March 9th, 2021

The tree grates and bike racks will require an approved encroachment. In order to petition for an encroachment, the city of Detroit will require:

# LA JOYA GARDENS

**PUBLIC SPACE SITE PLAN**

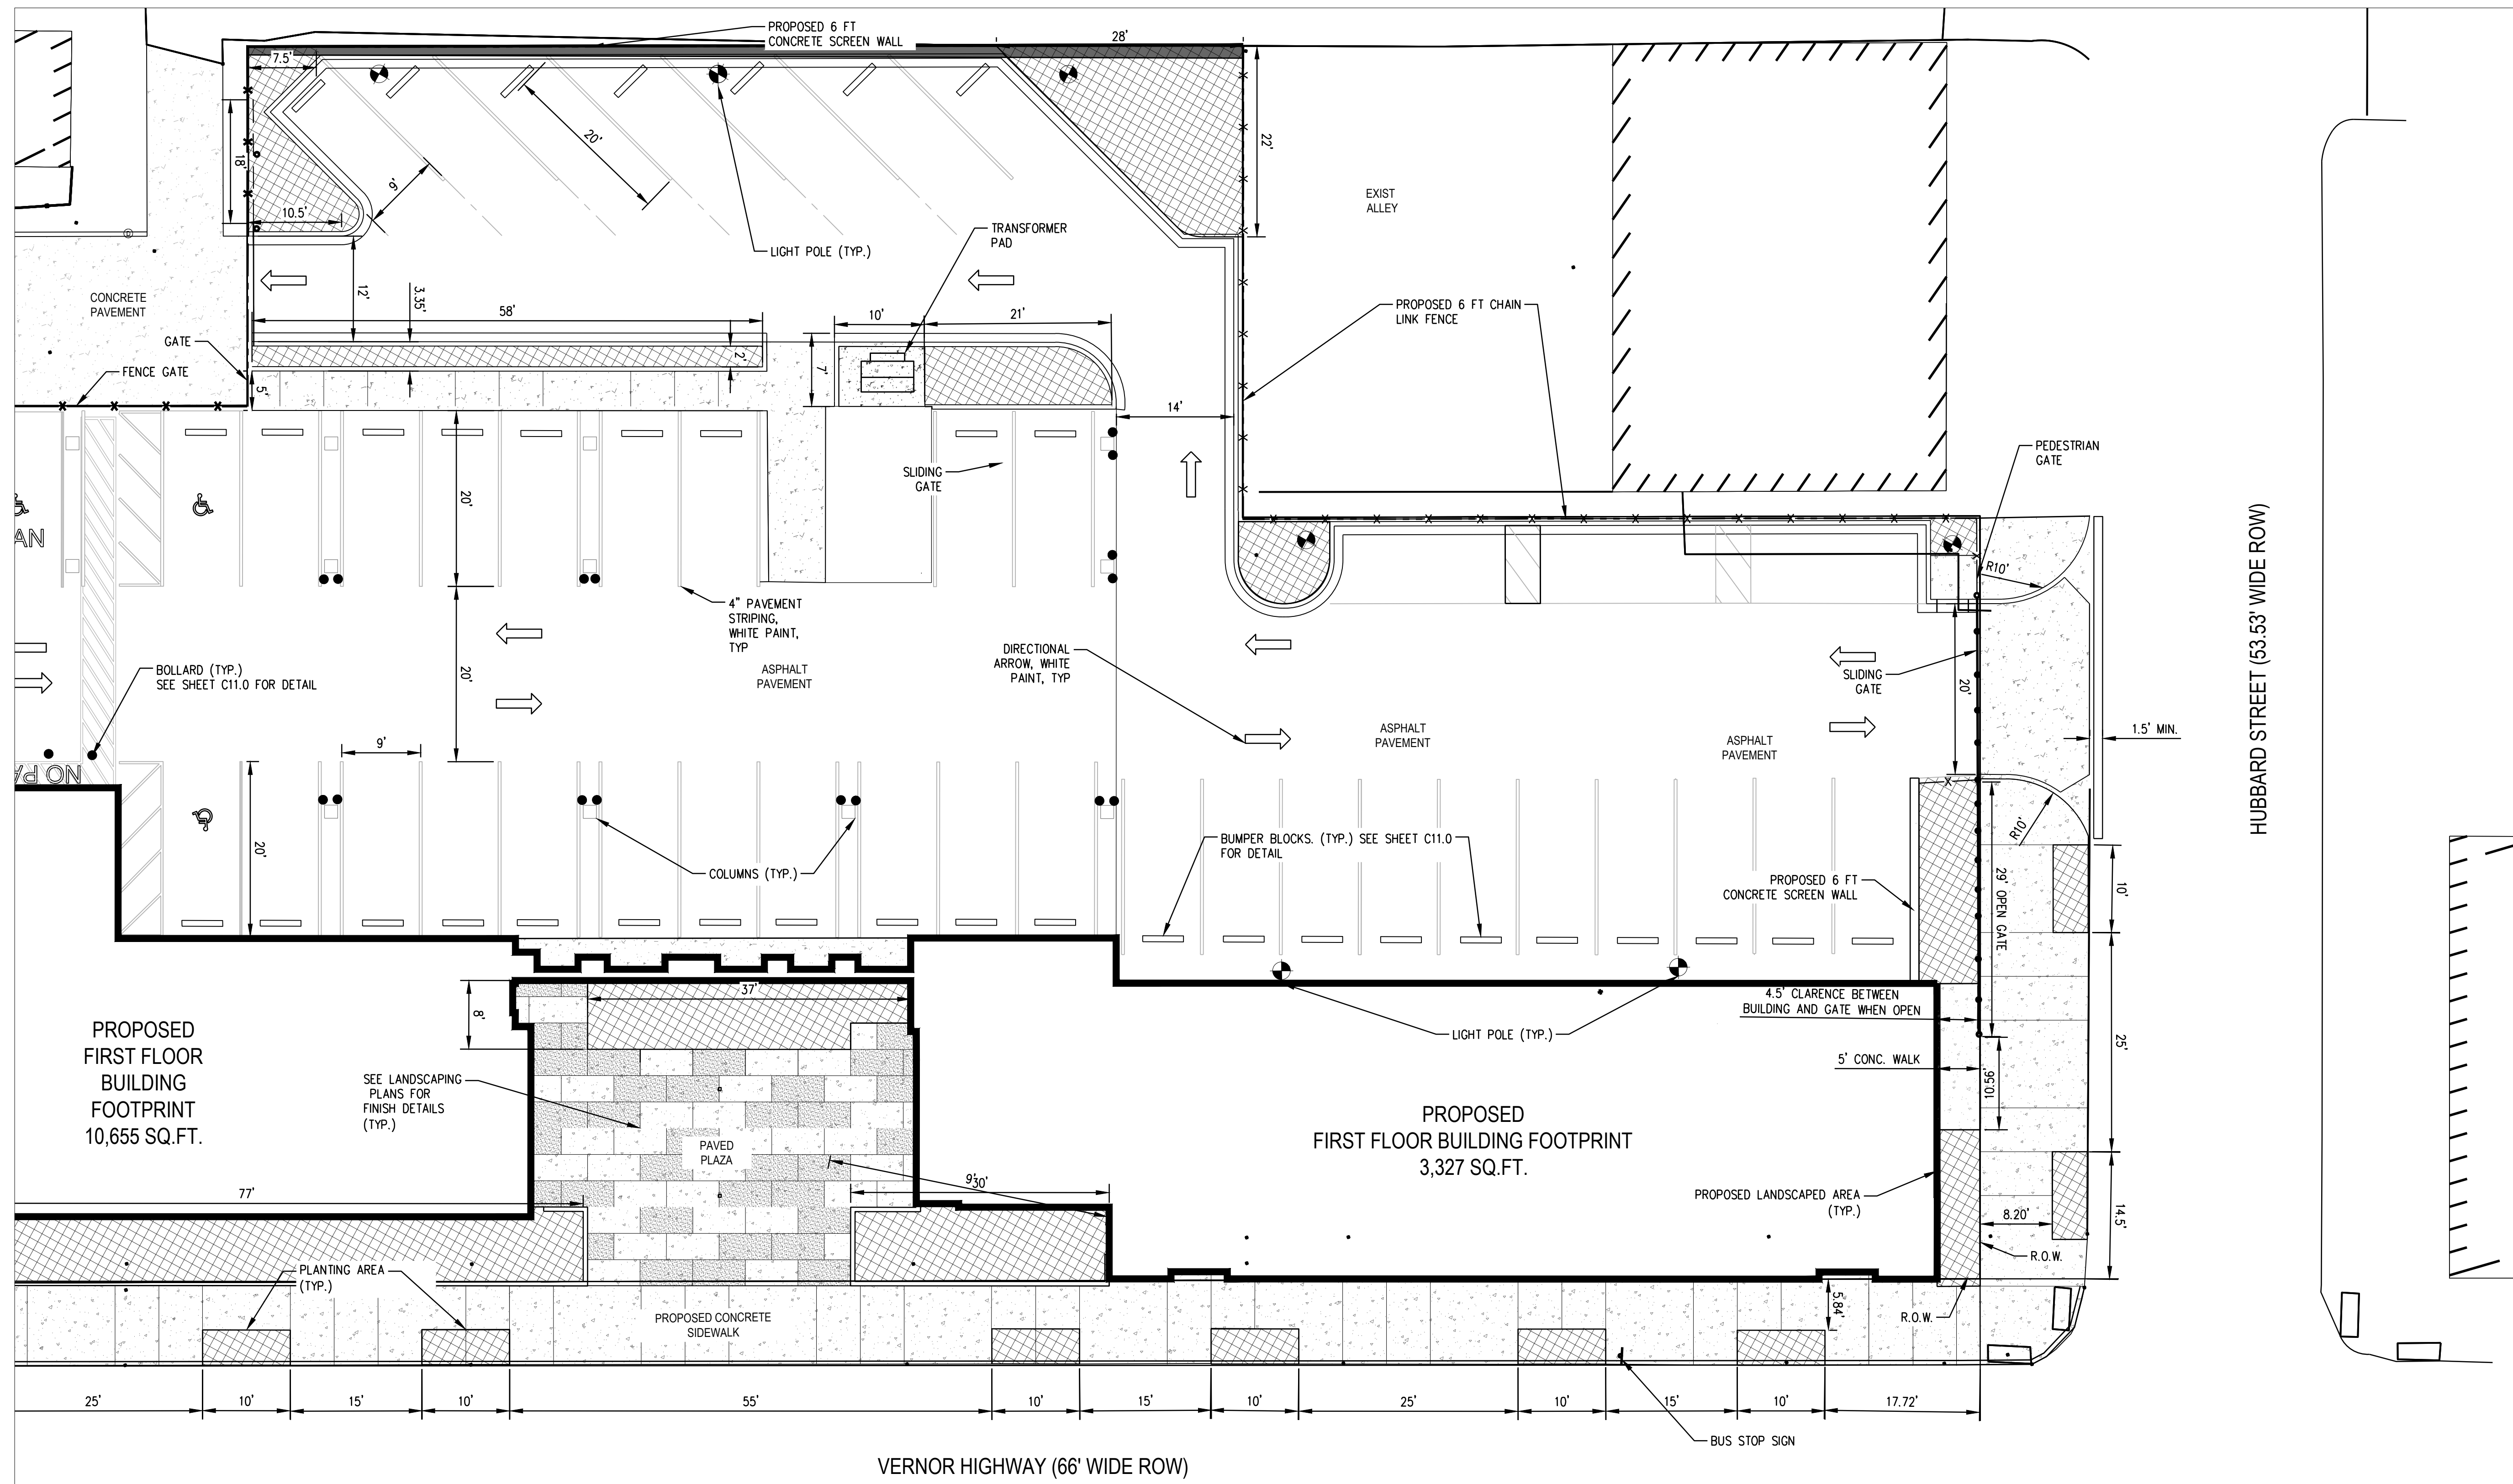
- 1. Site plan specific to the public space, which will highlight the dimensions of the grates and how far they are from the property line.**
  - Dimensions of the tree pits are on C4.1 and C4.2. Note that these are not tree *grates*. They are landscaped planting beds. The planting plan on L-800 indicates the planting schedule and locations.

- Sheets C4.1 and C4.2 were modified with measurements originating from the property line.

**L-105**

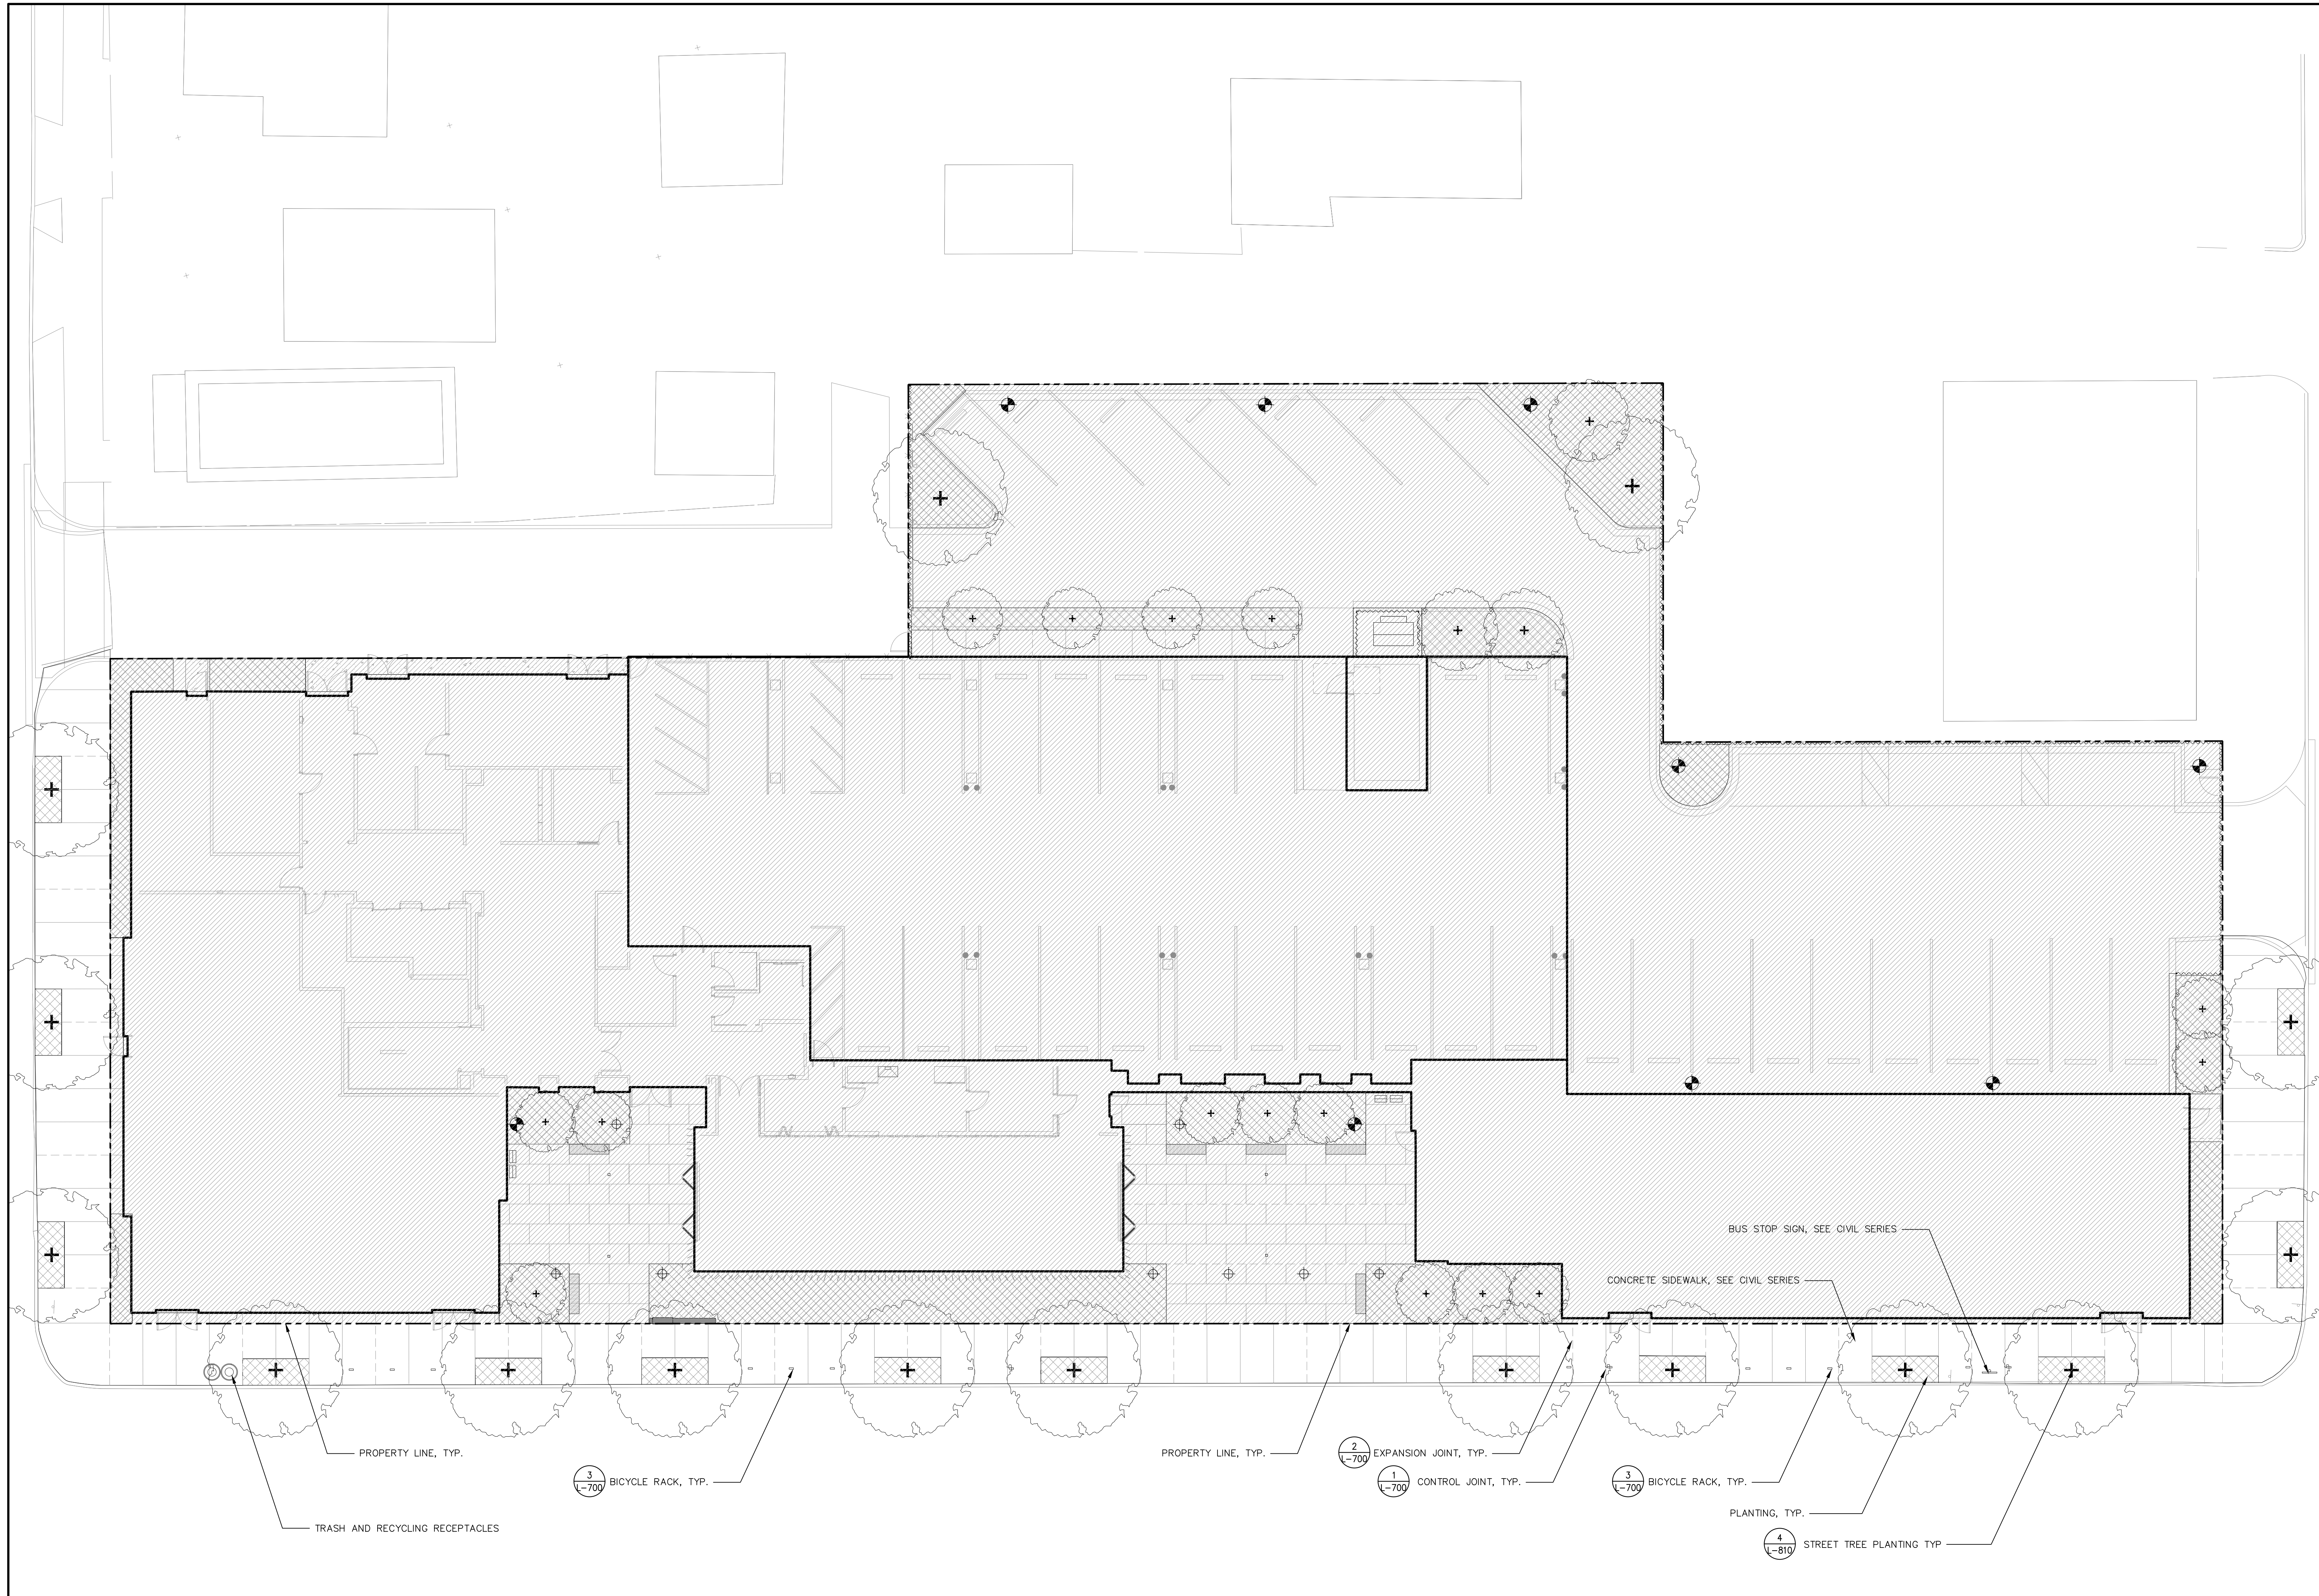
- 6. According with last comments received on March 03,2021.**
  - See new sheets modified, L-110 includes all requested dimensions
  - L-105 indicates the boundary between public improvements and our property line.
